Navistar Vehicle Recall G-05516

VEHICLE RECALL

G- 05516-R1

**SUBJECT: SAFETY RECALL (U.S., EXPORT)
SPECIALTY MANUFACTURING CO. 5 Series Electric
Stop Arms on certain 3800 chassis, and CE, FE, and
RE School Buses built between 01/07/2002 and
06/22/2005**

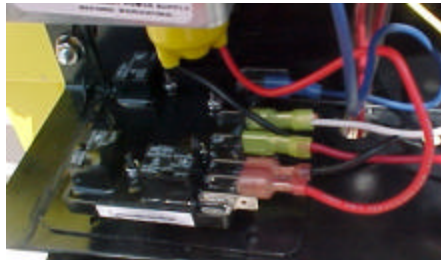
1. The bus may have only a front stop arm or a rear stop arm (California) or both a front and rear stop arm. Confirm that the stop arm is manufactured by Specialty Manufacturing Co and is a **5-series** stop arm (Specialty part number will start with a 5).
2. Confirm the stop arm serial number. The stop arm serial number should be in the range between **480380 and 627609**.
3. Replace the micro switch assembly by following the instructions below.
4. For problems installing the switch assembly, contact Specialty Manufacturing Company at 1-800-957-7867 ext. Customer Service.

<p>1. Remove ½-20 nut at the bottom of control box w/ ¾" wrench.</p>	<p>2. Use a screwdriver (or similar tool) to tap the cam shaft back up inside the unit.</p>	<p>3. Using a utility knife, cut the silicone seal on both ends of the stop arm cover.</p>

<p>5. Rotate sign for access & remove cover by using a flat bladed screwdriver to pry it off.</p>	<p>6. Remove camshaft and discard. It is not needed with 5.5 series.</p>

<p>7. Remove (2) 1 1/32" nuts holding micro switch assembly in position. DO NOT unscrew the four 1/4" nuts holding the micro-switches to the micro-switch assembly plate. The entire assembly will come out as one unit.</p>	<p>8. Carefully cut the wire ties.</p>

<p>9. Using a flat blade screwdriver, carefully pry the micro switch plate upwards. CAUTION-bushing may break and snap ring will make a loud noise when released. Discard the snap ring and bushing.</p>	<p>10. Remove all wires from micro switch assembly. Black heater wire remains with assy.</p>

<p>11. Remove the 11/32" nuts on both relays.</p>	<p>12. Disconnect wires from the relays. Discard relays, micro switch assembly & jumper wires – double orange, double black/green, brown & yellow.</p>

<p>13. Cut smaller (shorter) wire from the double red & double white pigtail sets.</p>	<p>14. Cut Fast-On end off of BLUE wire, strip end approximately 1/4" & crimp new 1/4" fast-on blade, 004024, included with kit.</p>

<p>15. Connect leads to new 005150 module as shown on schematic above. Leave two center tabs, +12VDC & GROUND, disconnected until module is fastened down in next steps. The yellow wire is no longer needed and can be tied back.</p>

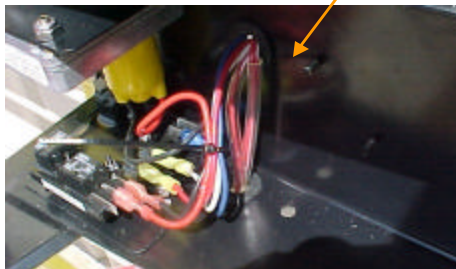
16. Install new 005150 module into position as shown above. Timing mark **MUST** be facing toward the direction of the blade. (Ex. If blade is fully extended, timing mark must be turned to front of unit). Push module shaft through lower hinge hole. Fasten with (2) 11/32" hex nuts from original micro switch assy.

17. Connect +12VDC & GROUND per schematic.

18. Secure with 3/4" nut.

19. Tie wires. If unit does not have drain hole, add one.

<p>20. Replace cover. Secure with (2) screws. Reseal both ends of the crossing arm cover with RTV. IMPORTANT! – DO NOT seal approximately 1” of the lower right side of the box. This provides an additional drainage location.</p>	<p>21. Test the stop arm assembly to make sure it functions correctly.</p>
<p align="center">If further help is needed, contact the engineering department at Specialty Manufacturing</p>
